475 HOWE STREET (COMPLETE APPLICATION)
DE416842 - ZONE CD-1 PENDING

DEVELOPMENT PERMIT STAFF COMMITTEE MEMBERS

DEVELOPMENT PERMIT STAFF COMMITTEE RECOMMENDATION: APPROVE

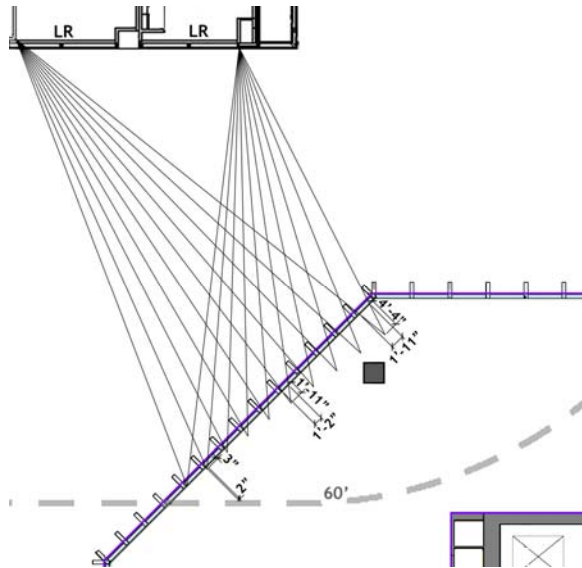
Design Development to address privacy impacts by eliminating direct sight lines from distances of 60 ft. or closer between the proposed office building and the existing residential units in the Jameson House.

Note to Applicant: These privacy measures between the two occupancies must be implemented as a permanent component externally integrated with the glazing treatment.

Staff assessment: The building design is composed with a vertical mullion expression that, within the area between the Exchange and the Jameson House, utilizes this architectural feature as a system to address the privacy interface between the two buildings. This is achieved by a combination of a deeper mullion (26") and reducing the mullion grid spacing to approximately 3'-6" along this vertical face to further limit the view aperture of the glazing.

Example detail of extent of translucent glazing based on occupant distance from window to observe full width.

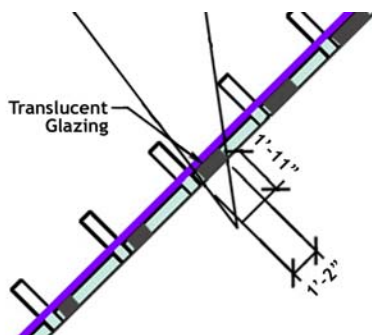
indicates the distance from the glazing an office occupant would have to be located to observe the full width of the primary living spaces (living rooms) of the Jameson. The distance ranges between 3" to 4' -4" from the window plane. A location beyond 53 ft. of separation would put the occupant outside of the glazing line to be able to see the full width of the Jameson.

However, the condition of rezoning has placed a performance requirement to eliminate direct sight lines from distances of 60 ft. or closer between the two buildings. Staff acknowledge that there is a significant challenge with achieving the performance requirement of eliminating direct sight lines for an office tenancy without resulting in a continuous blank wall condition. The Urban Design Panel commented that the proponent's effort and design response to address the privacy interface was a significant, well-considered solution and that the applicant had substantially addressed the issue.

Illustration A: Partial translucent glazing for windows to reduce limit extent of primary view aperture towards Jameson House based on occupant location 3 ft. from window plane.

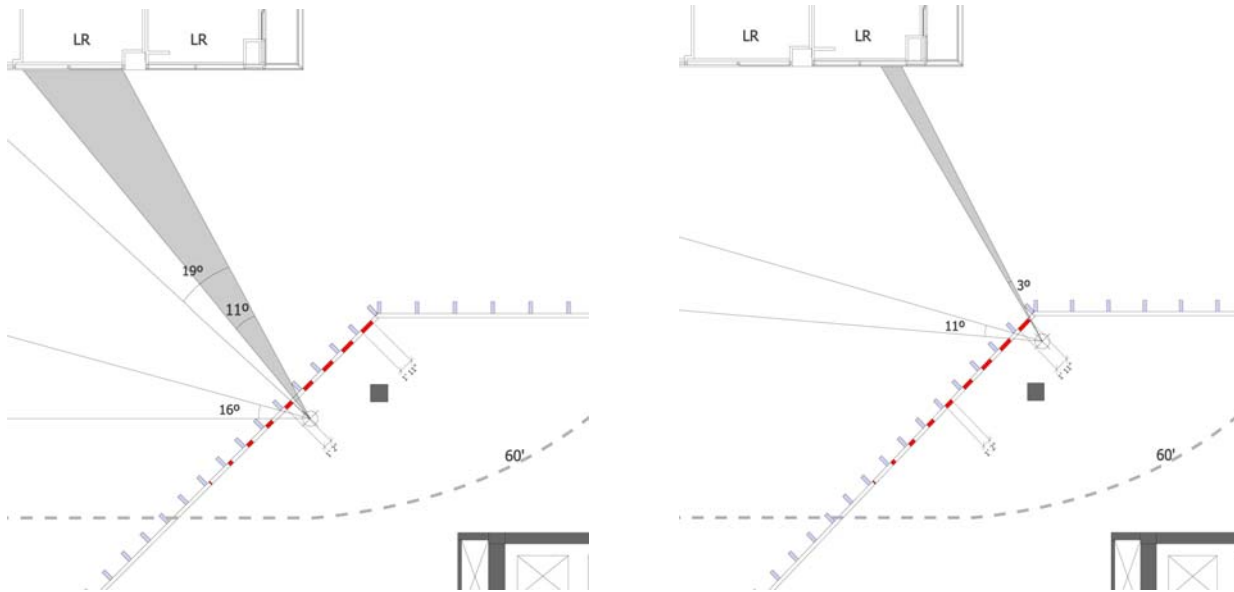
1.1 design development to further reduce the direct sight lines between the proposed and the existing Jameson Building through the introduction of an increasing amount of translucent glazing, generally as described within illustration A (page 9), or redirection the vertical mullions to the west, parallel to the lane, generally as described within illustration B (page 9).

Nevertheless, staff believe that in order to substantially meet the requirements of the rezoning condition, further measures need to be provided. To better address the substantive performance aspect of the rezoning condition, staff are recommending further design development to reduce the direct sight lines between the two buildings. Staff believe this could be achieved along the angled northwest corner through the introduction of translucent glazing for portions of the glazing panel (Illustration A below) or with redirecting the vertical mullions to the west, parallel to the lane (Illustration B below). See Condition 1.1.

Parkade Level 2-6 Plan

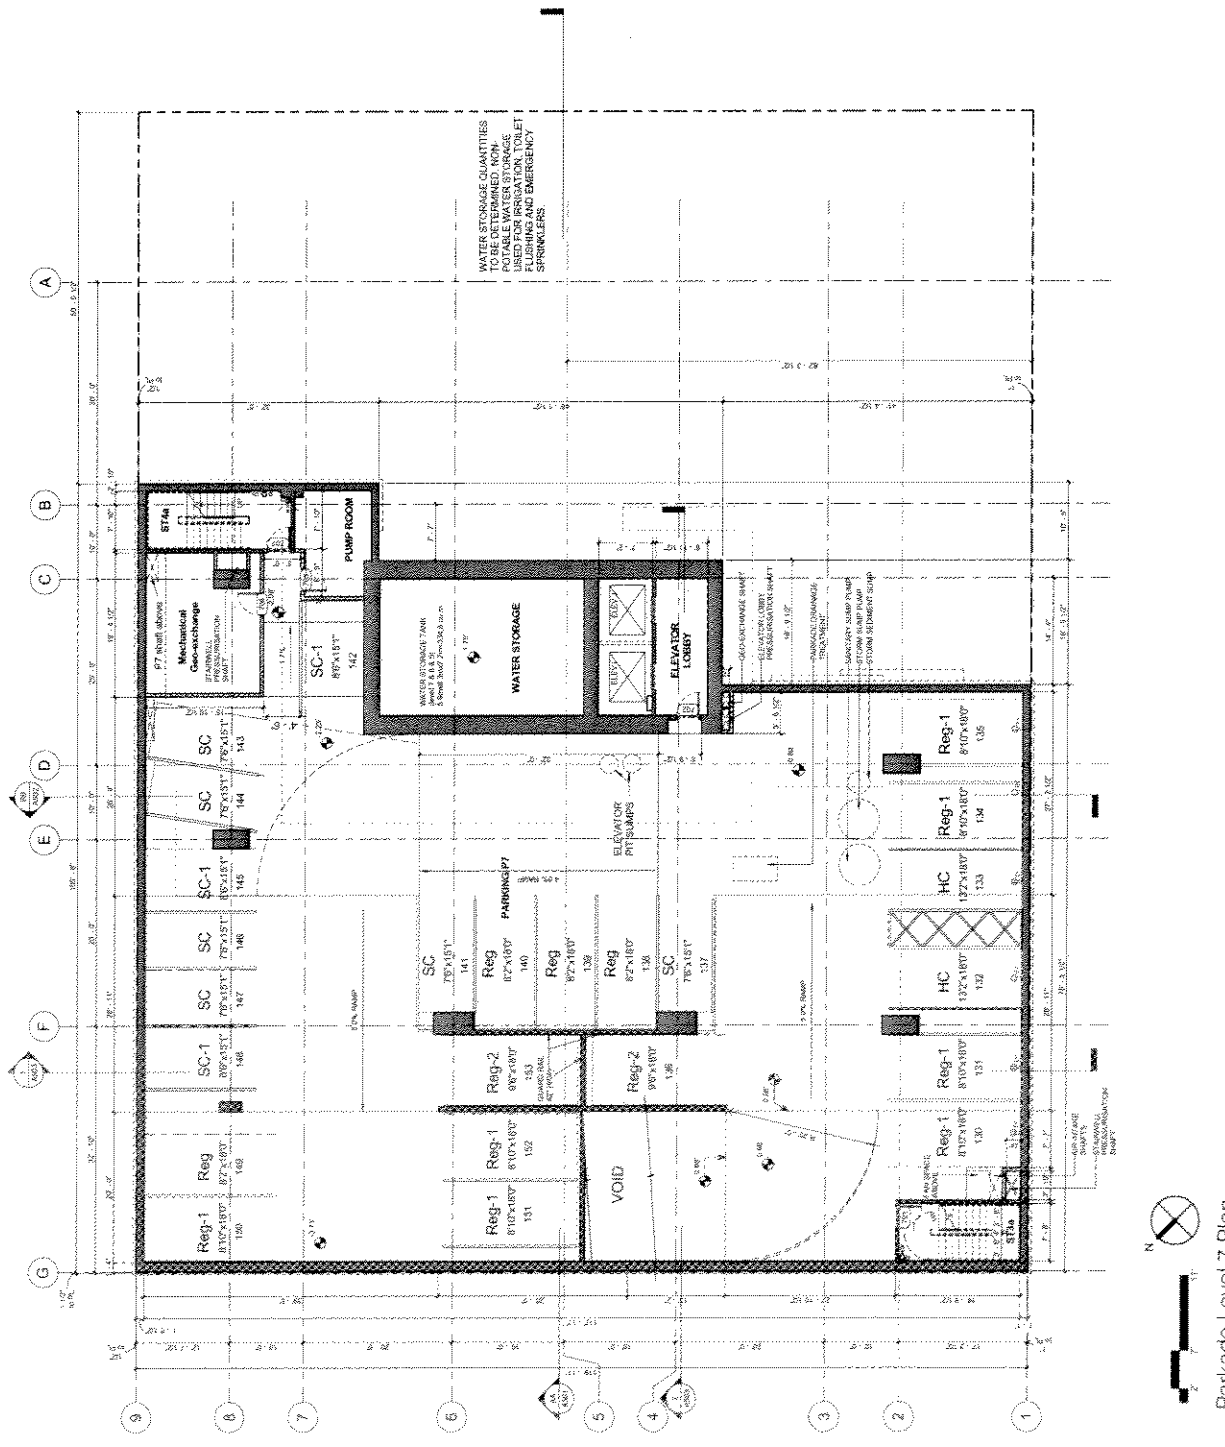
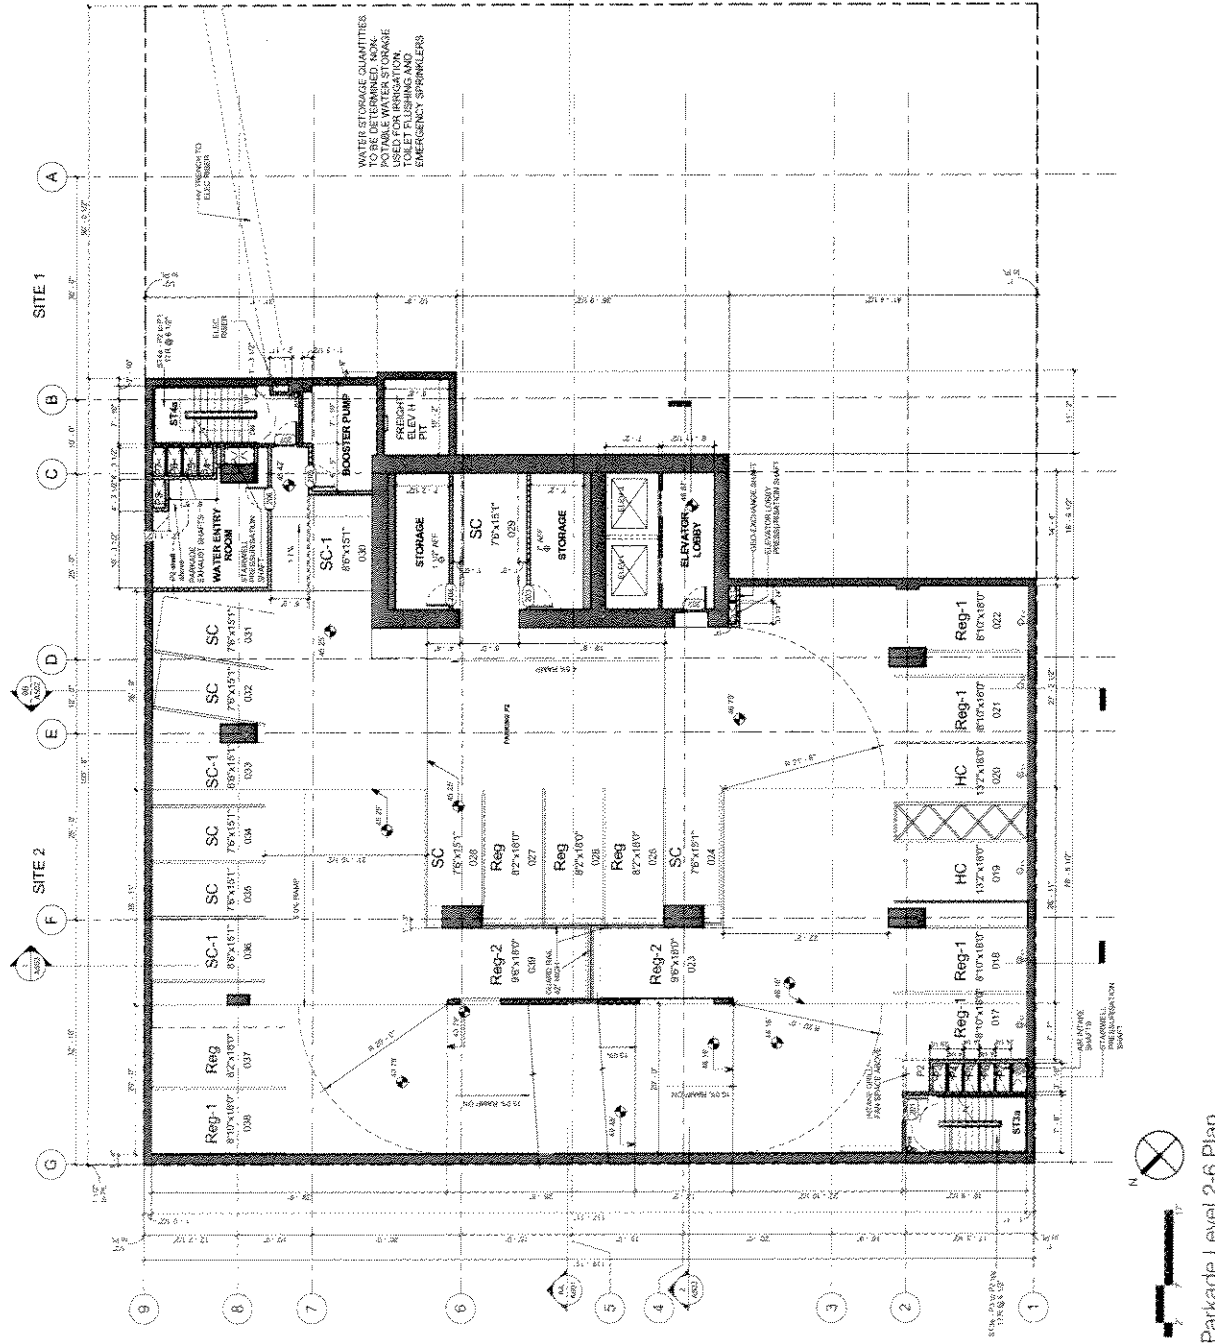
- i. all parking stalls should be numbered, and all parking stall and manoeuvring aisle dimensions should be shown on the plans;
- ii. a minimum parking stall width of 2.6 m (8'-6") is required for Parking Stall Nos. 32 on Parking Levels P2 to P6, and 144 on Parking Level P7; and

Parkade Level 1 Plan

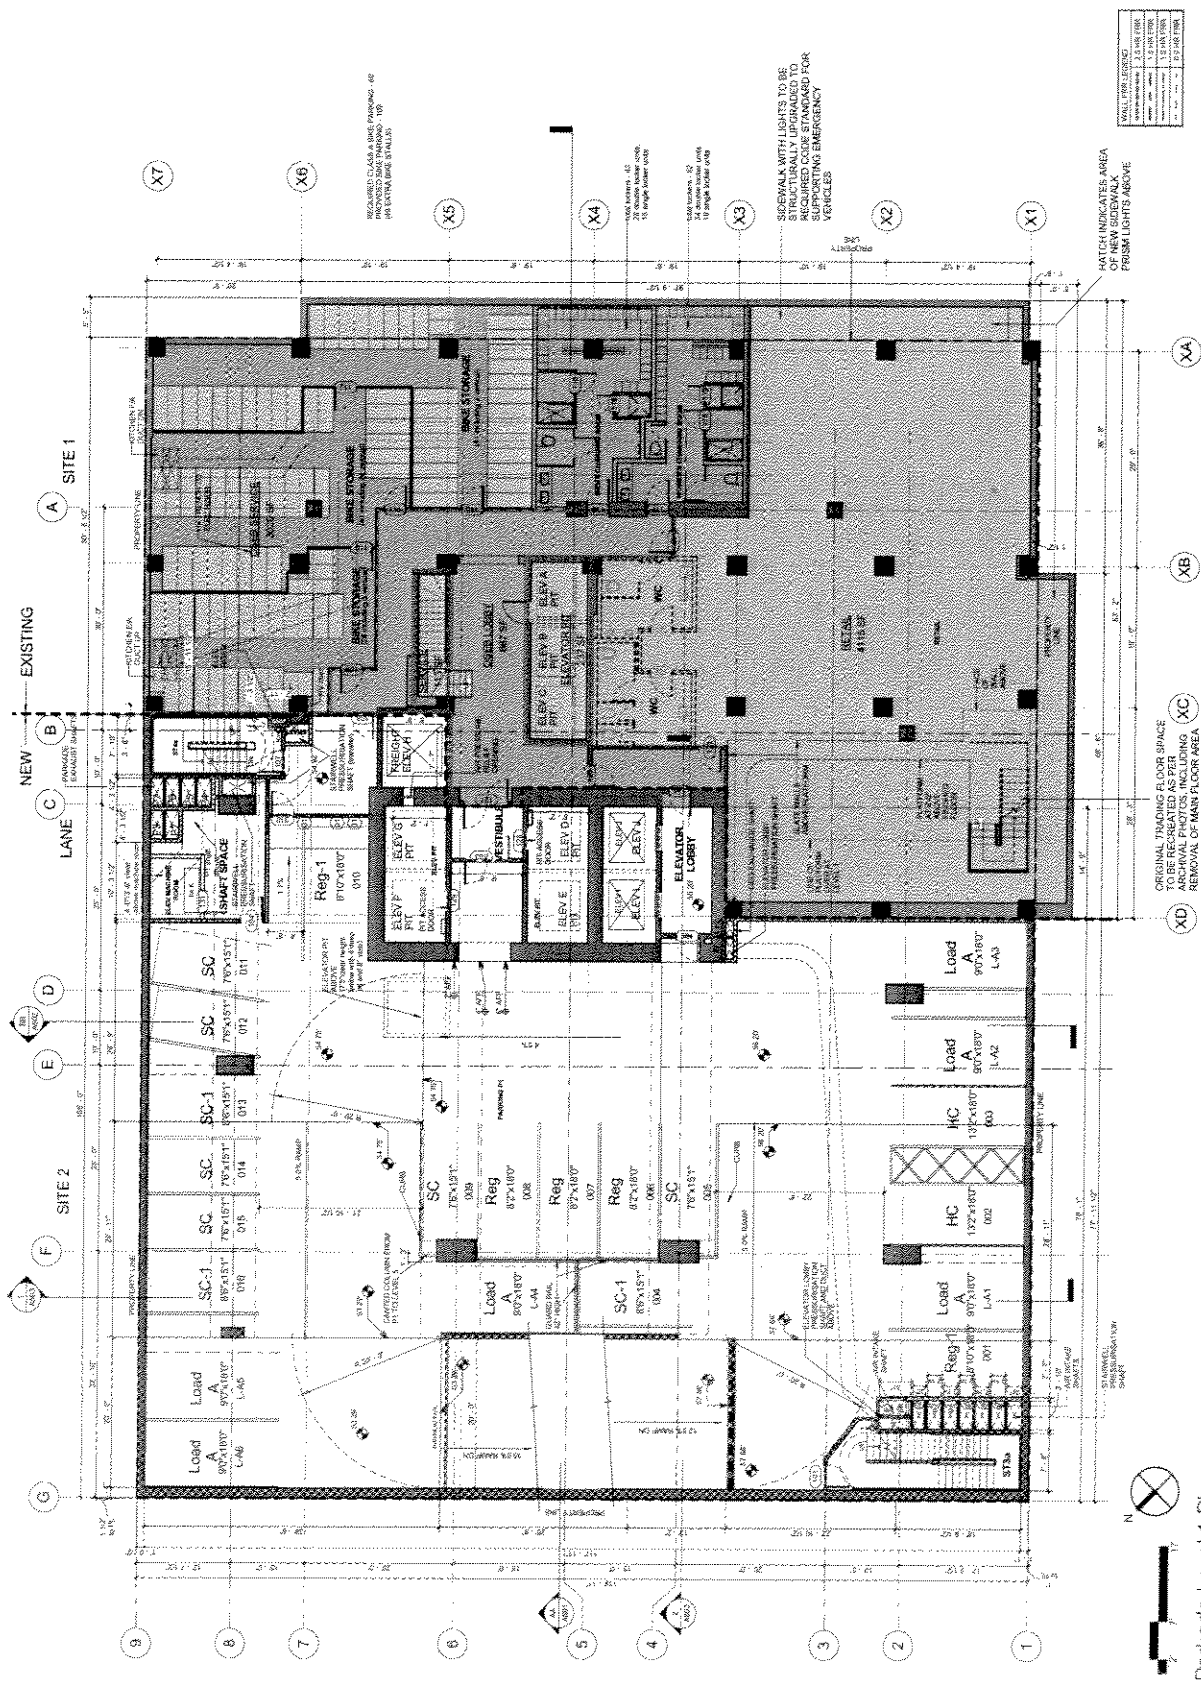
- i. modification of the bottom of the main parking ramp at Parking Level P1 to provide vehicle accessibility onto the corner-cut by way of an improved and gradual transition through the corner-cut;

- Note to Applicant:** Access onto the parking ramp by outbound vehicles uses the space in front of the small car parking stall for manoeuvring, but as designed, the vehicle must drive over the abrupt grade change where the parking ramp has a 12.5% slope.
-

- ii. provision of design elevations on both sides of the parking ramp at all break points including notation of the length of ramp at the specified slope, along the property line at the lane in front of the loading spaces, and also at the rear of the Class B loading spaces;
- iii. provision of a section drawing showing the main parking ramp from grade to Parking Level P1;
- iv. provision of overhead security gates at the building face on the lane for both the main parking ramp and the loading spaces;
